ADDENDUM No. 3
FOR
LINK – Multi-Use Development
BID PACKAGE – All Trades

Date of Issue: April 24, 2023

LINK – Addendum #3 Narrative

4/21/23

4 UNIT 1F
S151 1/4" = 1'-0"

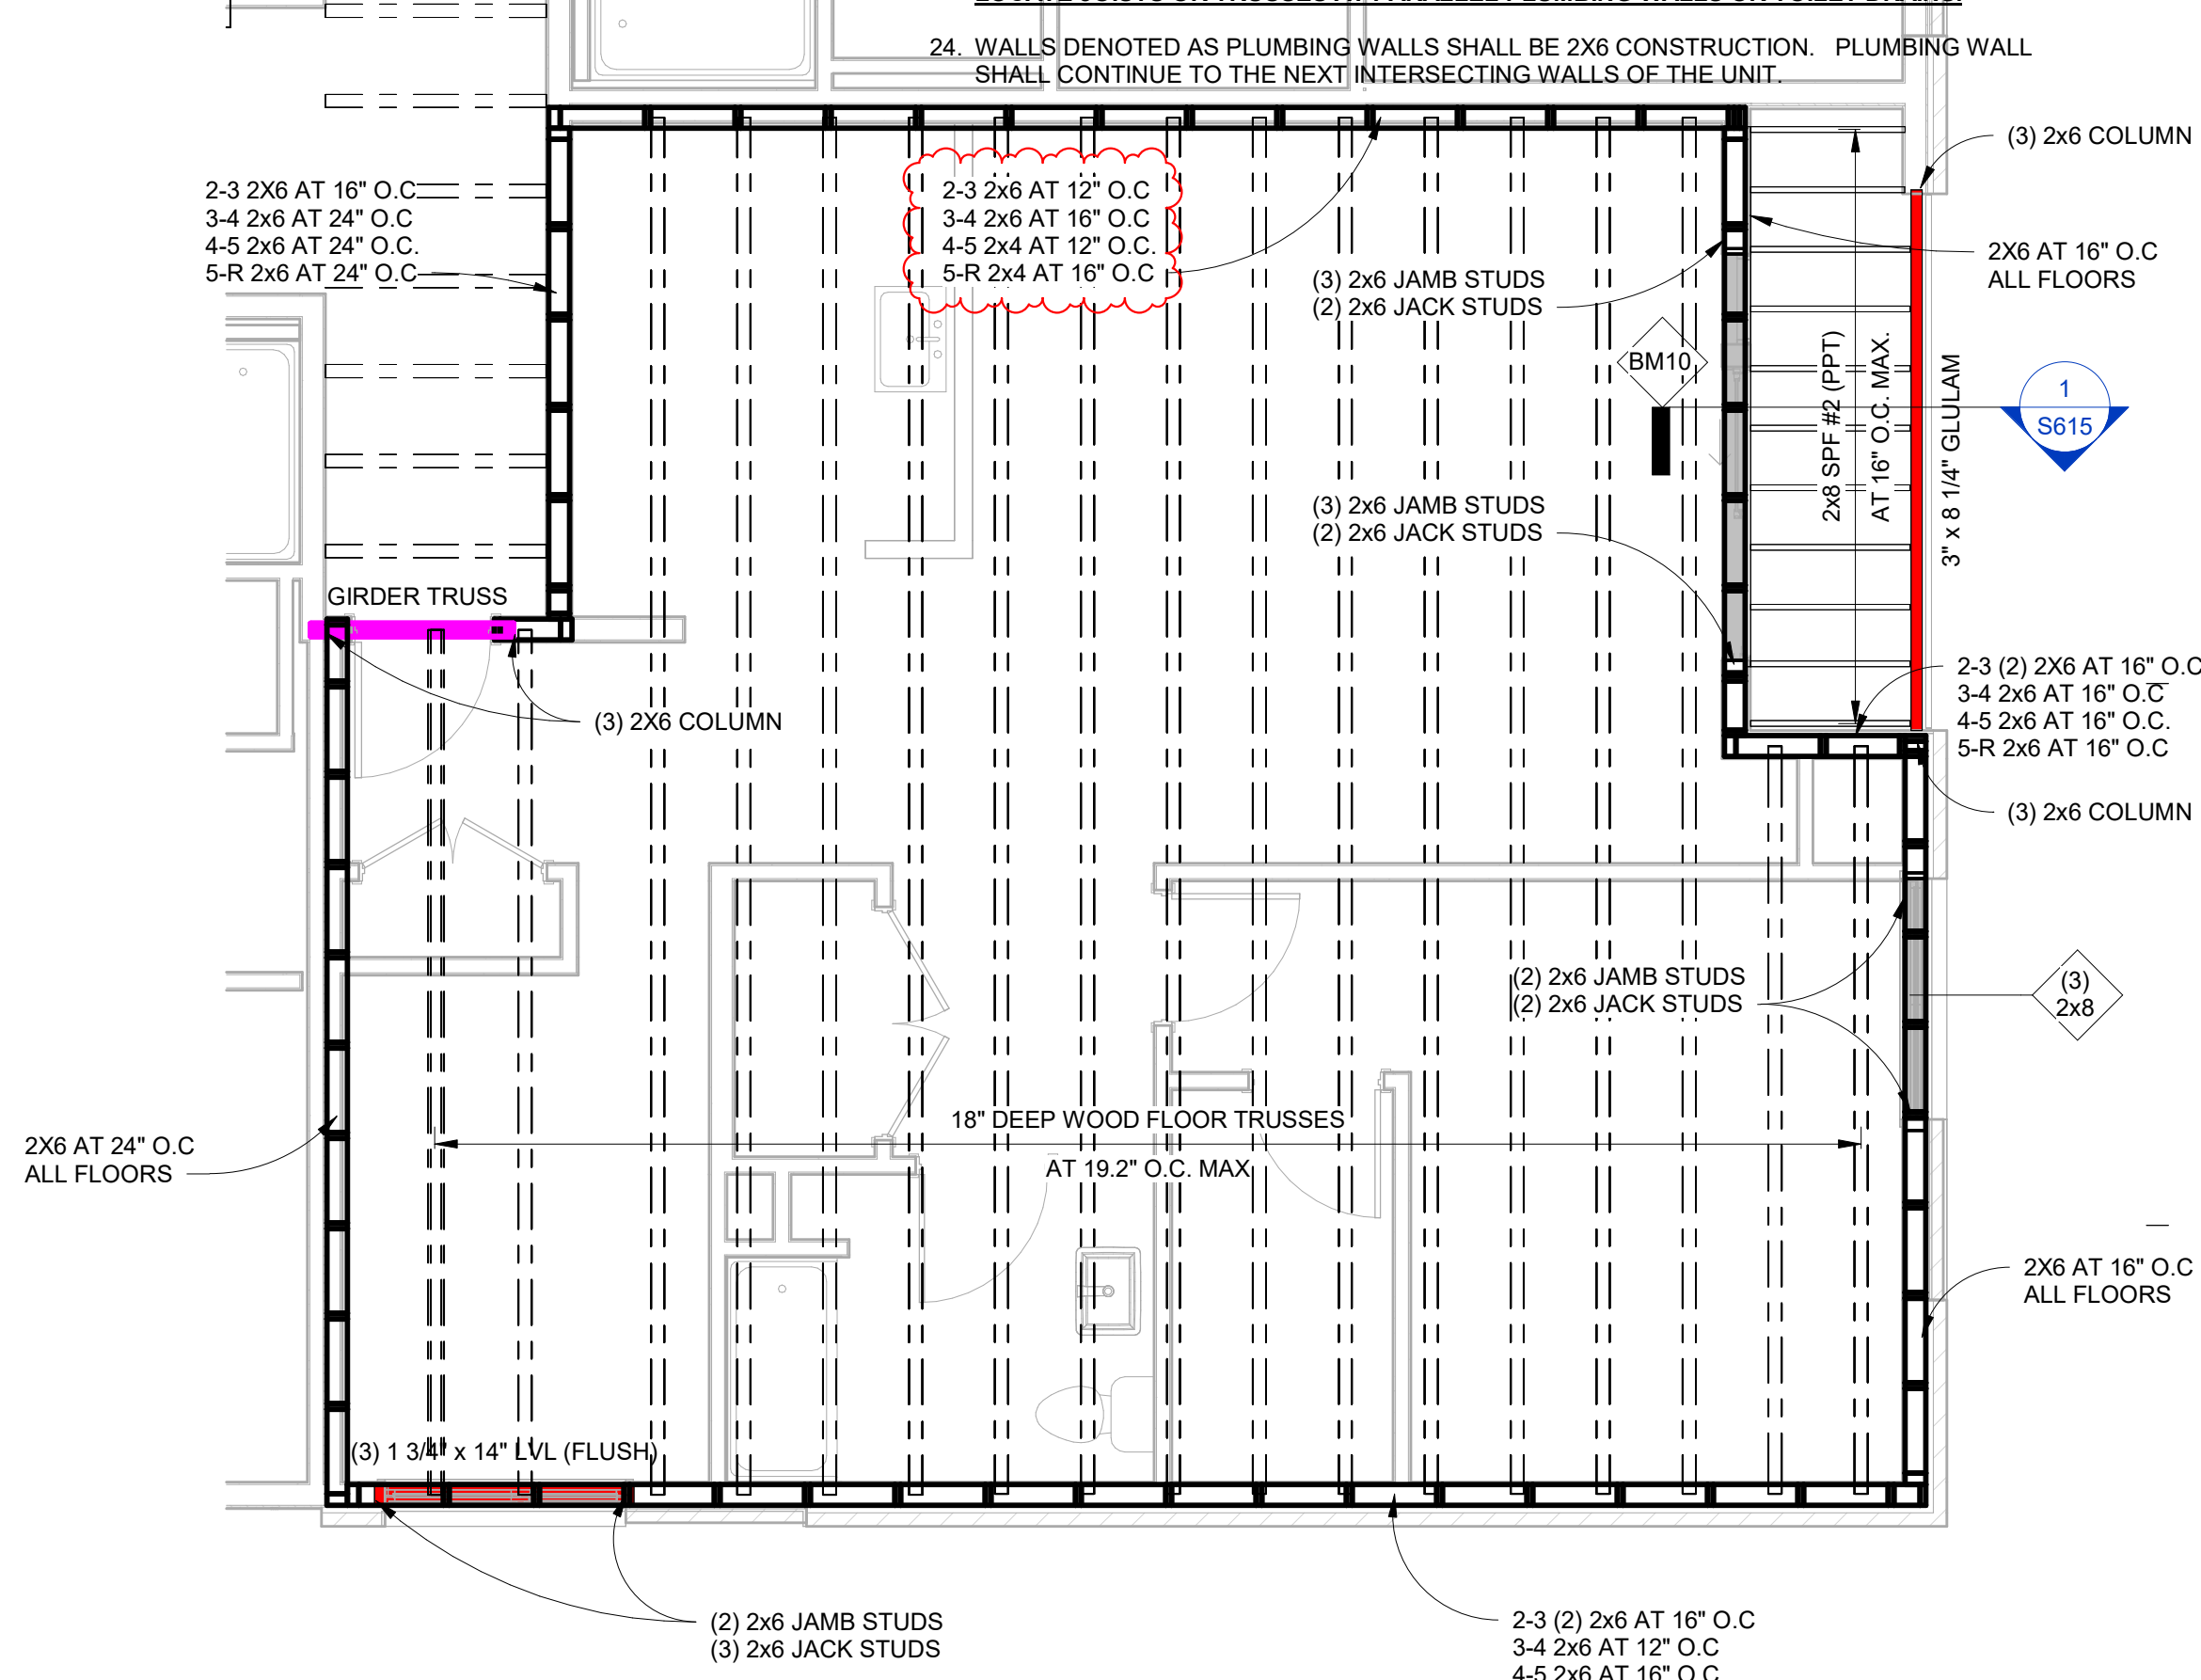
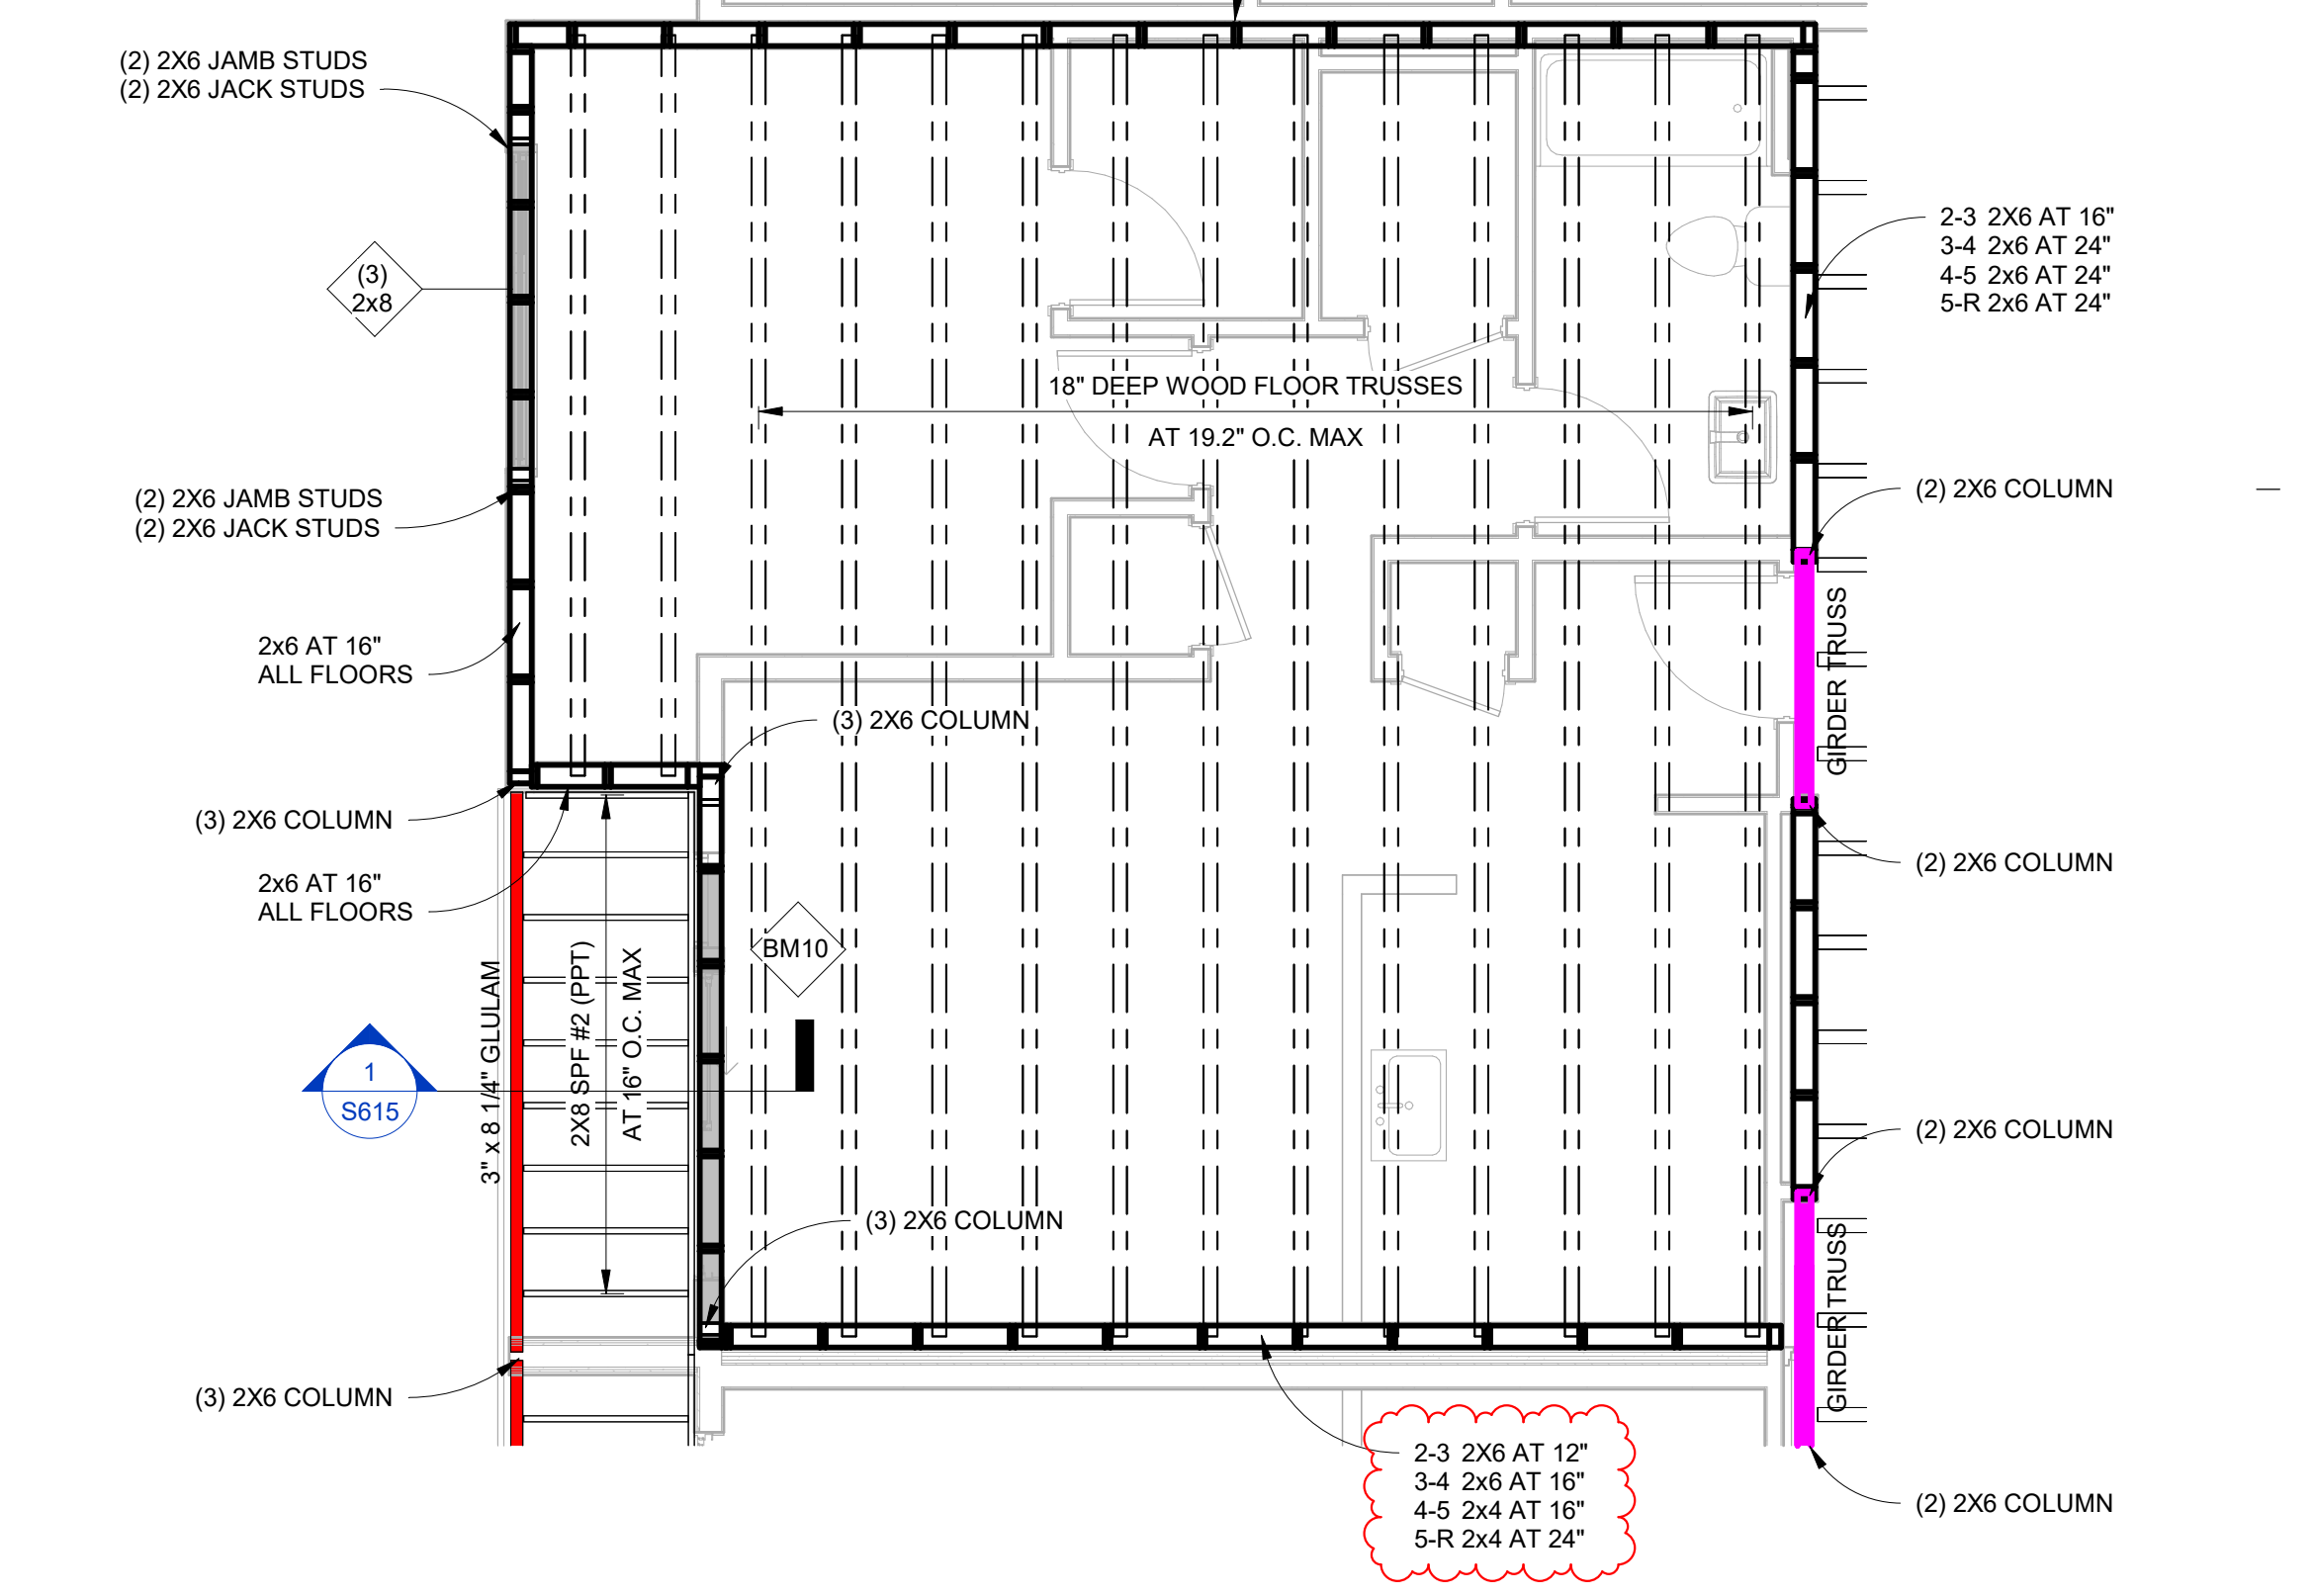
- S150
 - Revised studs at upper floor demising walls to 2x4 studs where indicated.
 - S151
 - Revised studs at upper floor demising walls to 2x4 studs where indicated.
